RE: Response to TCEQ NOD 3 Addendum – CCR105
Luminant Generation Company LLC – Tatum, Rusk County
Industrial Solid Waste Registration No. 31277
EPA Identification No. TXD000821306
Tracking No. 27220868; RN102583093/CN603256413

Table 1 - NOD Summary and Response
Registration No. CCR105 - Luminant Generation Company LLC
Application Deficiencies - Addendum to NOD 3

RE: Response to TCEQ NOD 3 Addendum – CCR Registration No. CCR105
Martin Lake Steam Electric Station - Rusk and Panola Counties, Texas
(SWR 31277; RN102583093; CN603256413; EPA ID No. TXD000821306)

Plot Date: 11/20/25 - 1:02pm, Plotted by: thgh
Drawing Path: C:\Users\thgh\OneDrive\Documents\250611301, Drawing Name: Martin Lake Steam Electric sections 25-1120.dwg

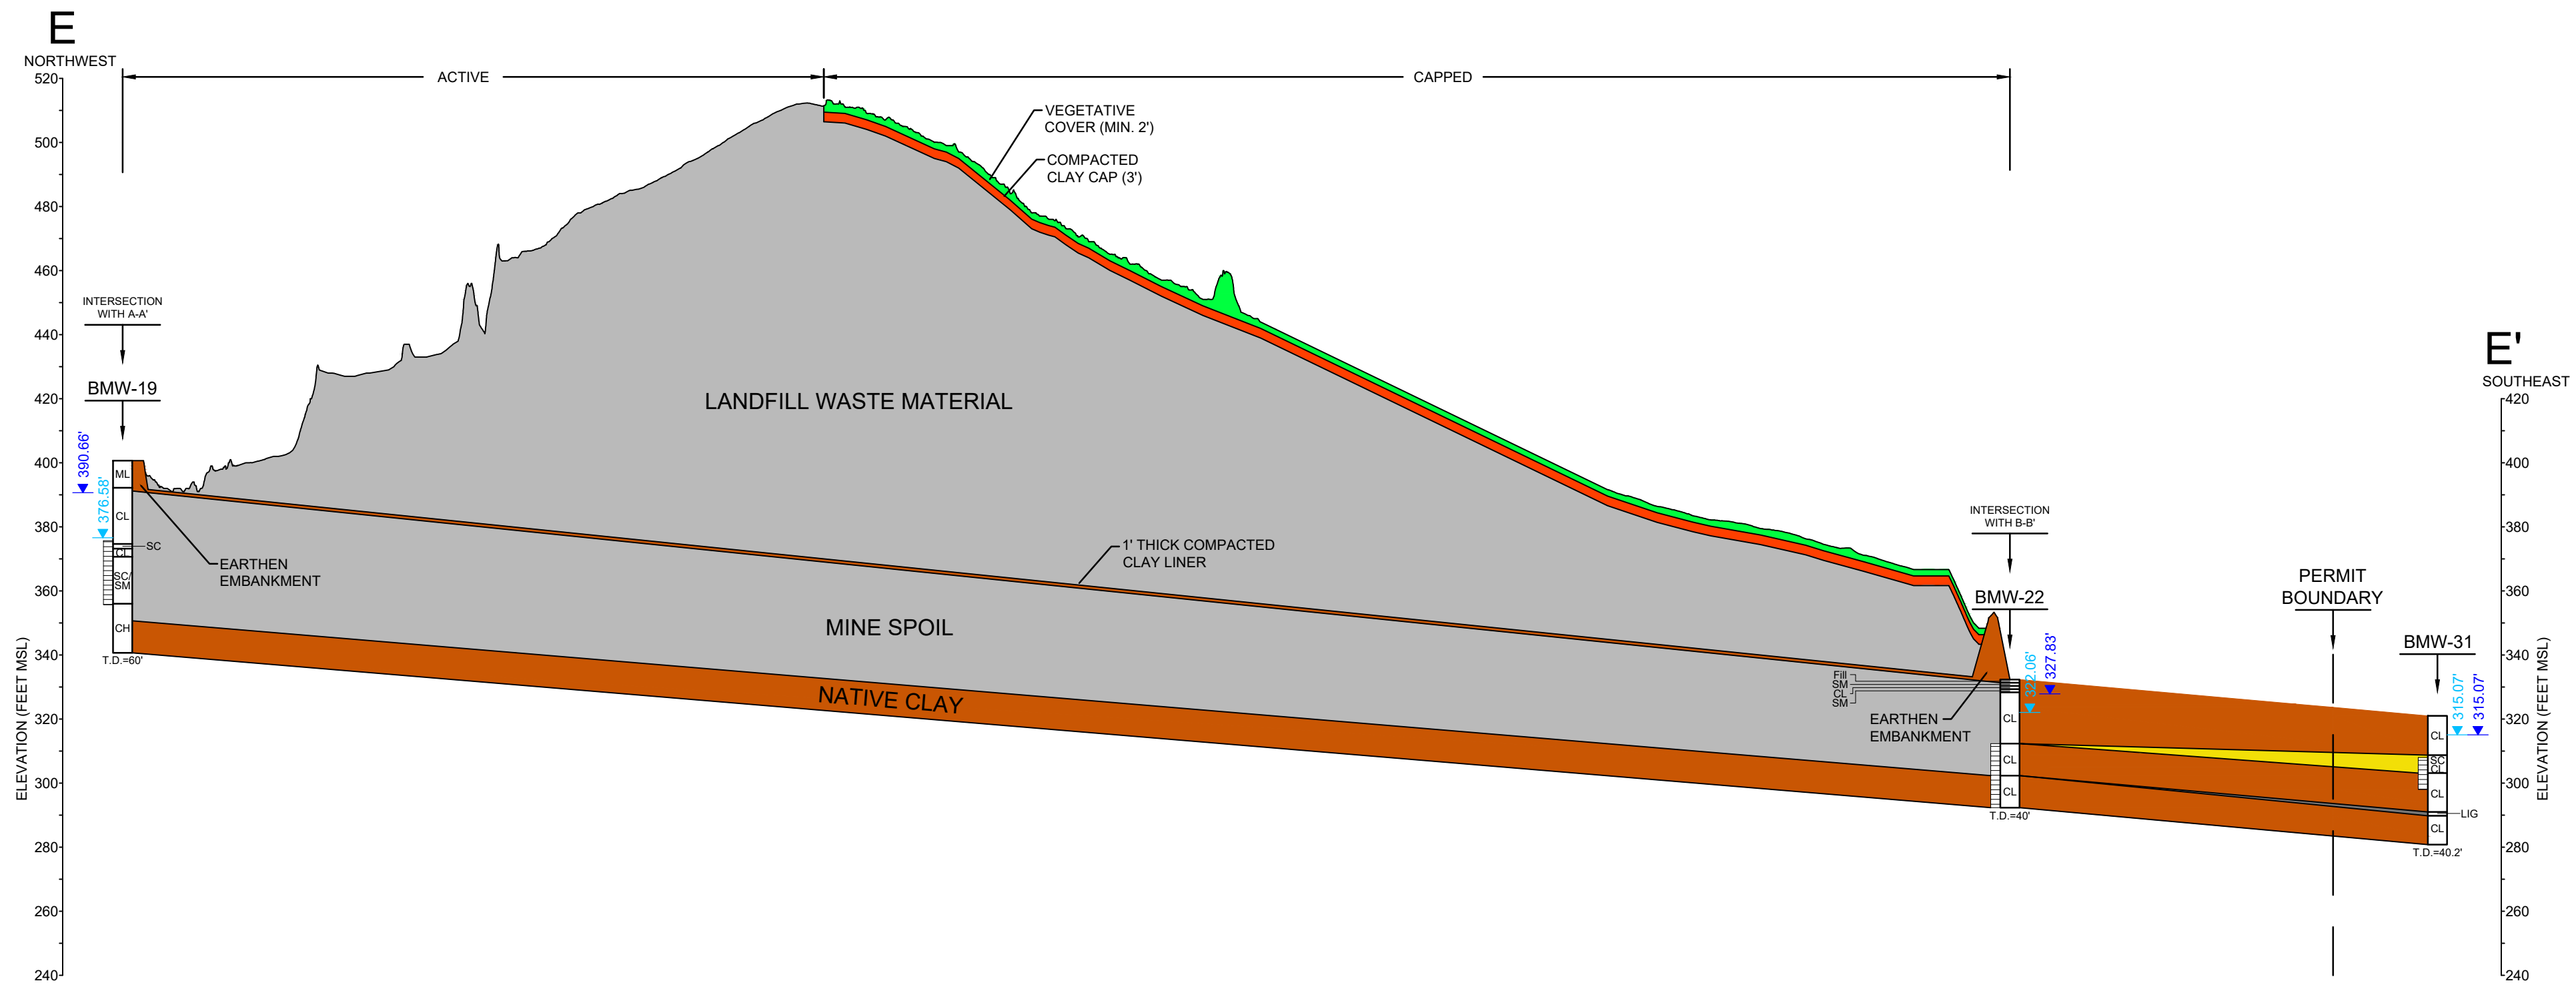
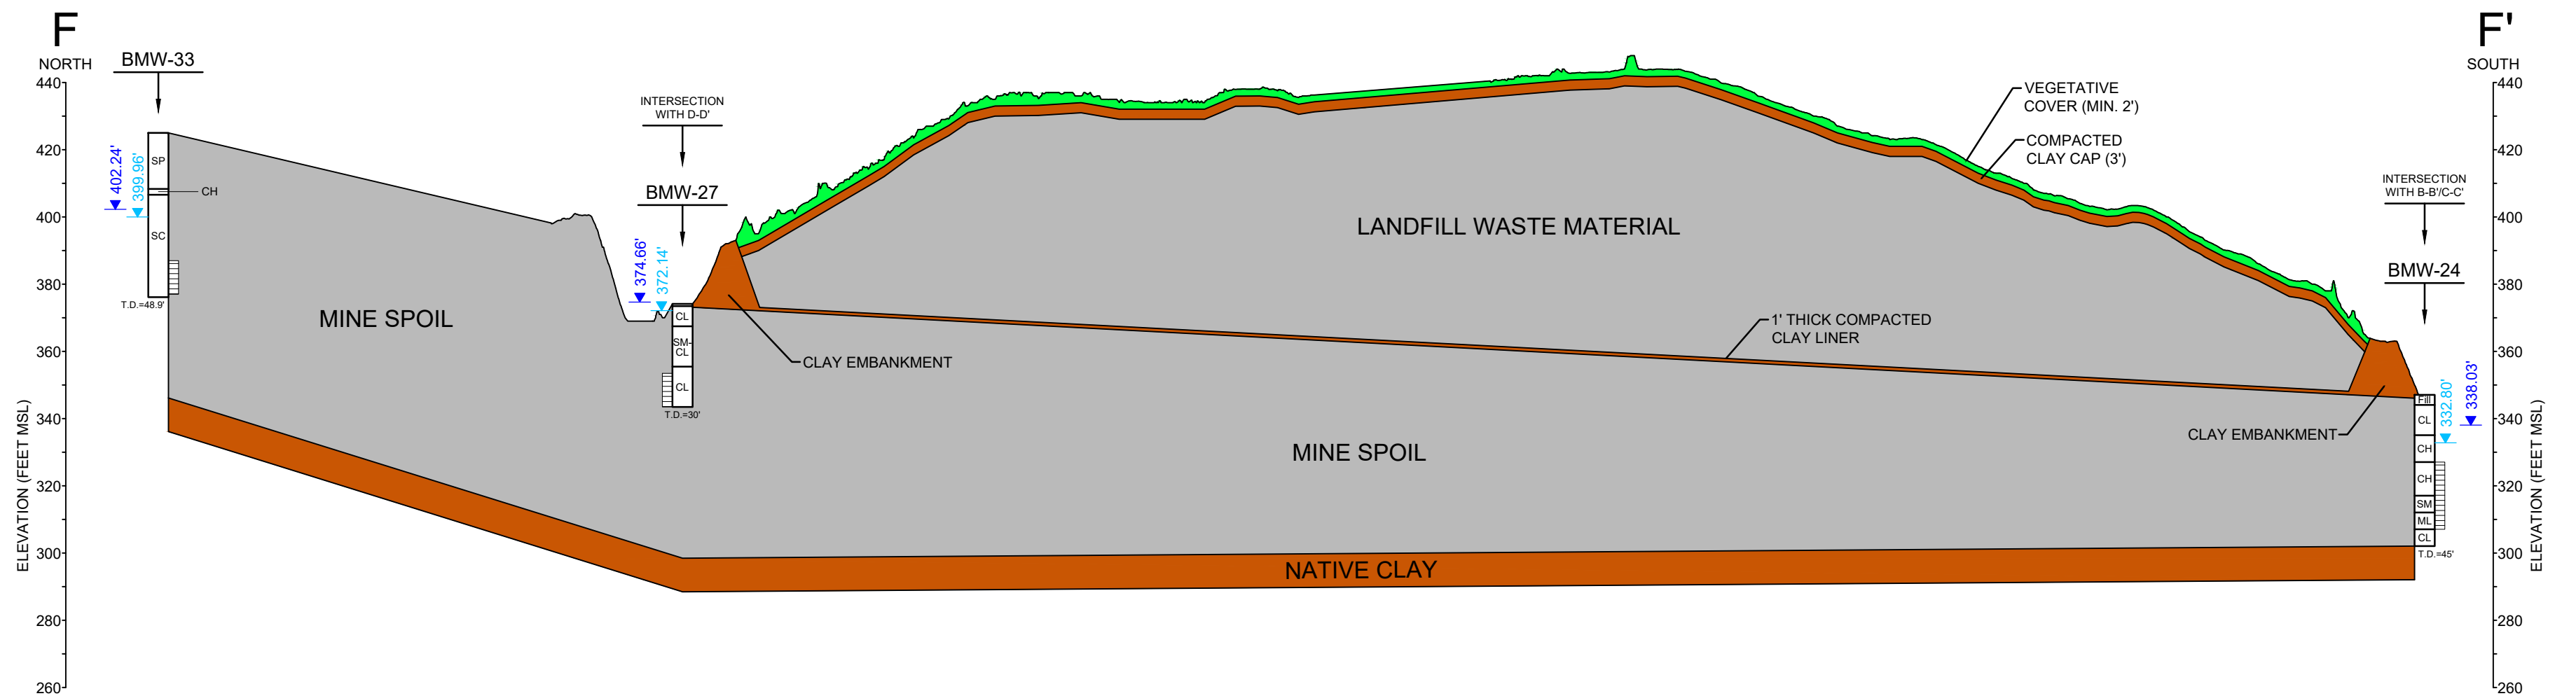
[A1 Landfill:] Provide North-South and East-West geological cross sections across the landfill down to the bedrock and beyond the boundary of the mine spoils showing the local subsurface geology in the vicinity of the landfill along with the projected nearest wells to the cross sections. Also, provide the maximum and minimum historical groundwater levels on the monitoring wells in the cross sections.

Response: The requested A1 Area Landfill cross sections are provided in Attachment 2.
